Serial: HNP-17-001

Shearon Harris Nuclear Power Plant, Unit 1  
Docket No. 50-400/Renewed License No. NPF-63

Subject: Summary of 10 CFR 50.54(q) Evaluation

**PEP-241, Technical Support Center (TSC) Emergency Ventilation System Operation, Revision 6**

## Attachment 2 - (Information Use) Technical Support Center Floor Plan Sheet 1 of 1

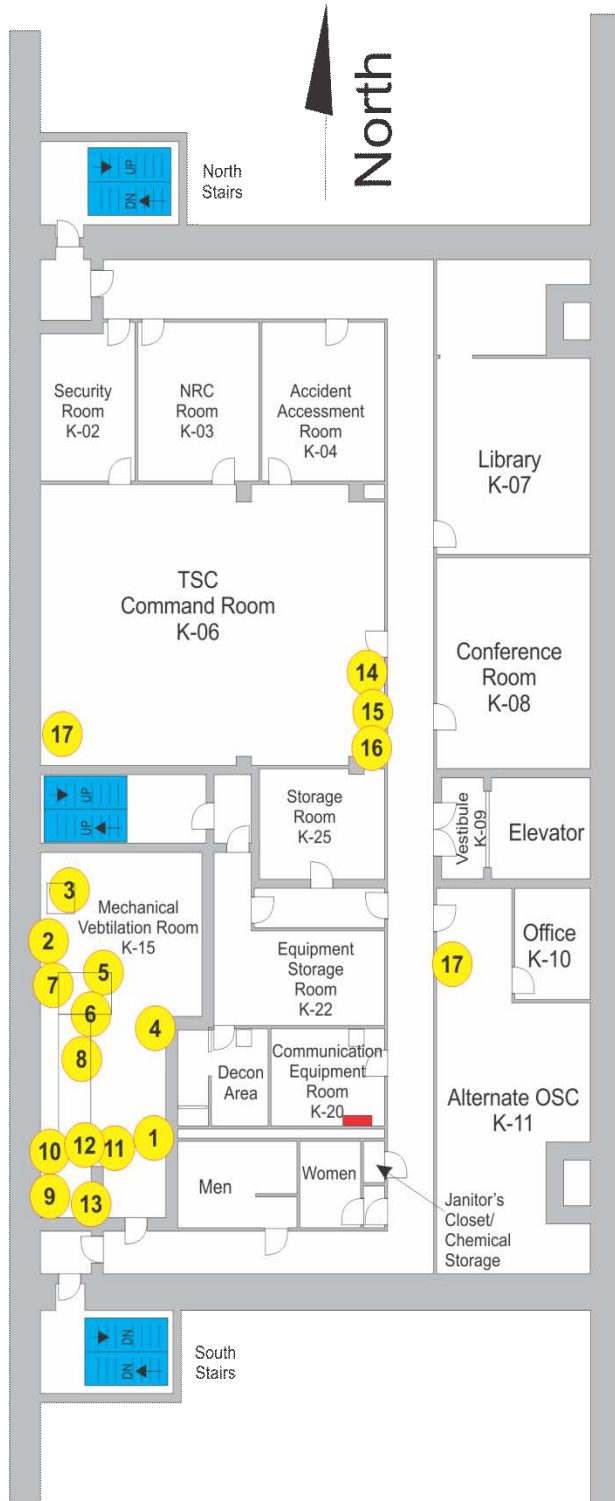
Section 9.4.5	[EC 401284] Added the following: <u>K-11 Alternate Operations Support Center</u> TIC-1TSC-AH10 (TSC AH-10 Thermostat) <u>K-04 Accident Assessment Room</u> TIC-1TSC-AH11 (TSC AH-11 Thermostat) Updated the following description for TIC-1TSC-AH17: <u>K-06 Command Room</u> TIC-1TSC-AH17 (AH-17 Thermostat) indication
Attachment 1	[EC 401286] Revised Normal alignment From: 2. Verify 1TSC-E003:003 (OA-2 Motor Starter Hand Switch) <sup>(2)</sup> is ON. 3. Verify DS-1TSC-E003 (Disconnect Switch for OA-2) <sup>(2)</sup> is ON. 4. Check 1TSC-E003 (Outside Air Intake Fan OA-2) <sup>(3)</sup> is operating. To: 2. IF 1TSC-E003:003 (OA-2/OA-3 Motor Starter Hand Switch) <sup>(2)</sup> is in OA-2 position, THEN verify the following lineup: a. DS-1TSC-E003 (Disconnect Switch for OA-2) <sup>(2)</sup> is ON. b. 1TSC-E003 (Outside Air Intake Fan OA-2) <sup>(3)</sup> is RUNNING. c. 1TSC-E067 (Outside Air Intake Fan OA-3) <sup>(3)</sup> is OFF. 3. IF 1TSC-E003:003 (OA-2/OA-3 Motor Starter Hand Switch) <sup>(2)</sup> is in OA-3 position, THEN verify the following lineup: a. DS-1TSC-E067 (Disconnect Switch for OA-3) <sup>(2)</sup> is ON. b. 1TSC-E067 (Outside Air Intake Fan OA-3) <sup>(3)</sup> is RUNNING. c. 1TSC-E003 (Outside Air Intake Fan OA-2) <sup>(3)</sup> is OFF.
